Response to Runway Extension Planning Discharge Conditions relating to Drainage

Response to Runway Extension Planning Discharge Conditions relating to Drainage

September 2022

Second page of Appendix A (page 15 of the file) – Image showing testing locations, note PT3 is in the location of the proposed infiltration measures:

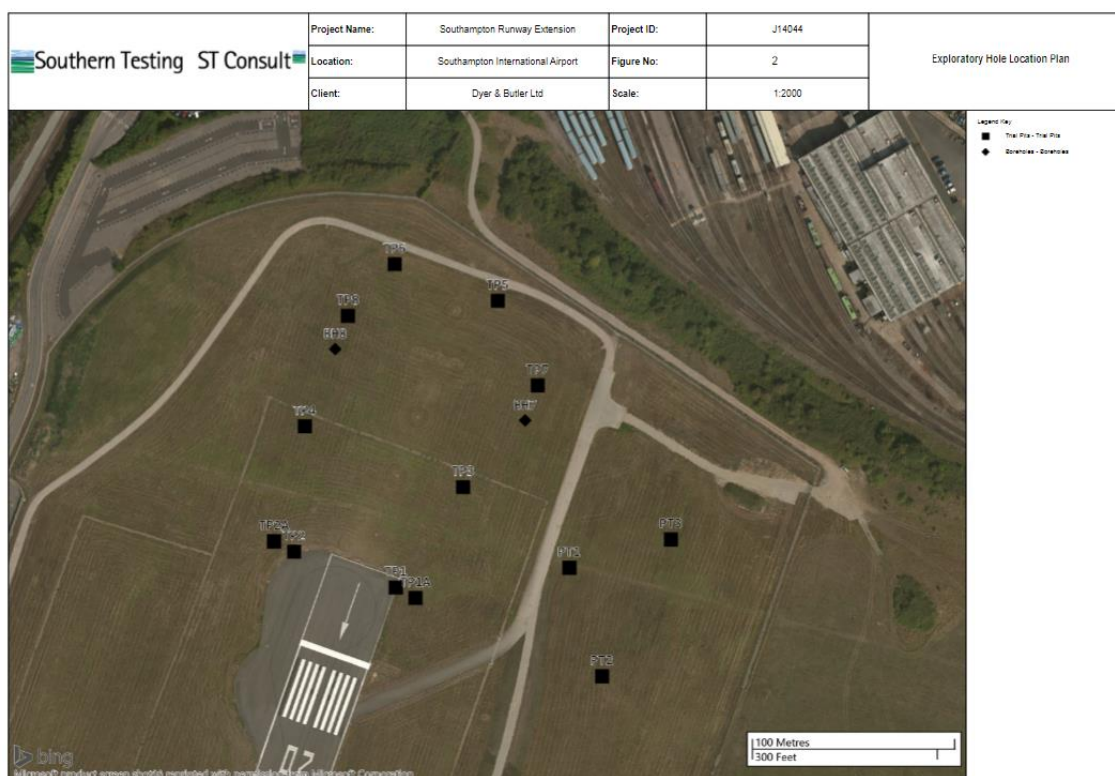
2 Infiltration test results undertaken in accordance with BRE365 and providing a representative assessment of those locations where infiltration features are proposed

Refer to pages of Factual Ground Investigation Report, Revision 6 (25th July 2019) by Southern Testing /ST Consult (Appendix B), for requested confirmation. Relevant extracted information below for ease of reference:
